County of Los Angeles Comments

LOS ANGELES RIVER AND TRIBUTARIES METALS TOTAL MAXIMUM DAILY LOAD

**COMMENTS OF THE COUNTY OF LOS ANGELES DEPARTMENT OF
PUBLIC WORKS ON PROPOSED AMENDMENTS TO THE LOS ANGELES
BASIN PLAN TO INCORPORATE A TMDL FOR METALS IN THE LOS
ANGELES RIVER WATERSHED**

**TECHNICAL REVIEW OF
PROPOSED METALS TMDLs FOR
THE LOS ANGELES RIVER AND
BALLONA CREEK WATERSHEDS**

Figure 1 – Event Mean Concentrations on Logarithmic Scale

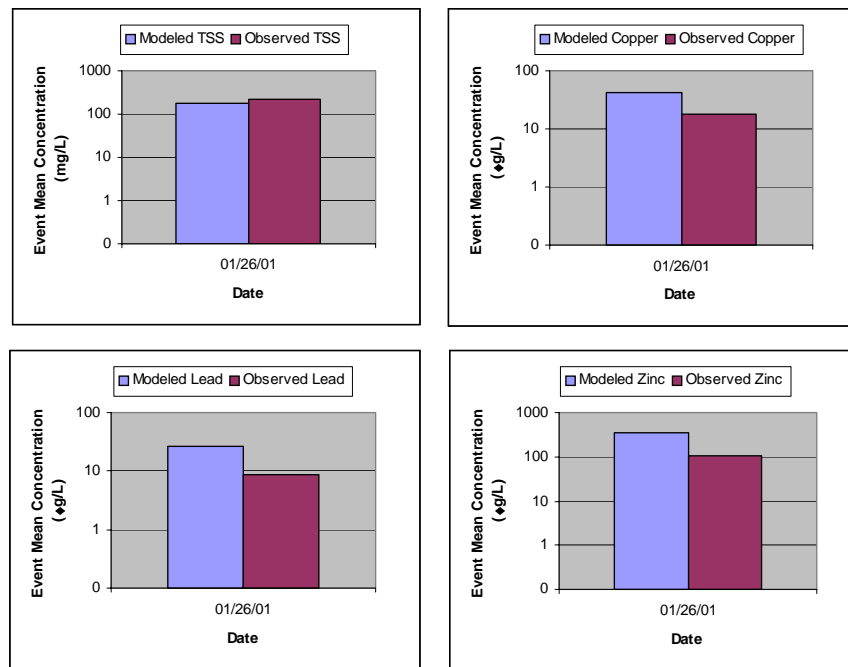
physical processes governing constituent transport in runoff, though they may yield appropriate model results given the linear relationship between sediment and metals.
